PLANNING NMA

Eton House | Explore
18-24 Paradise Rd, Richmond TW9 1SE

Rev 01

1 Consented vs Proposed Drawings

2.7 Consented - North Elevation

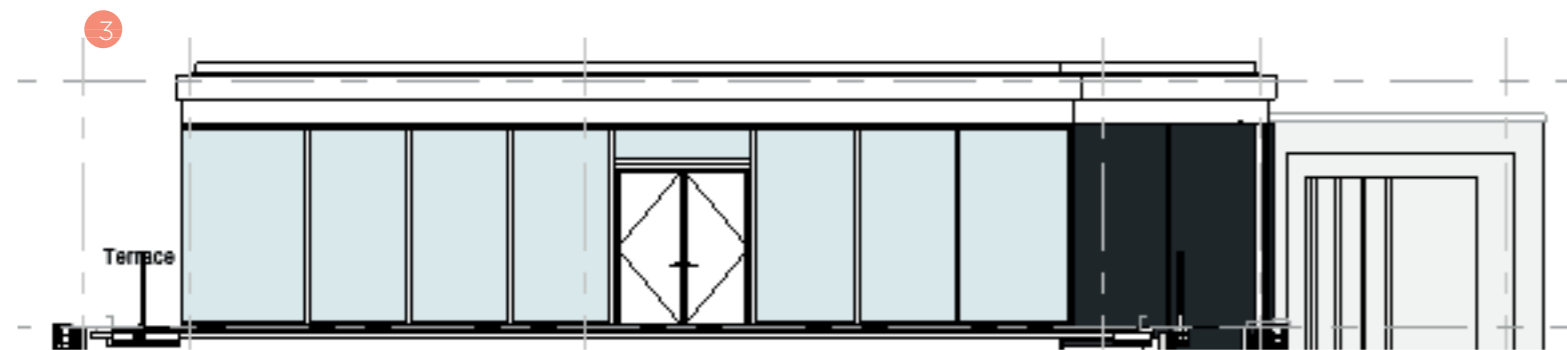
- 1 reduced fins due to build-ability constraints and to appear less cluttered
- 2 Planning set blocked this out
- 3 Additional mullions not shown here. See screenshot
- 4 As per previous elevation comments
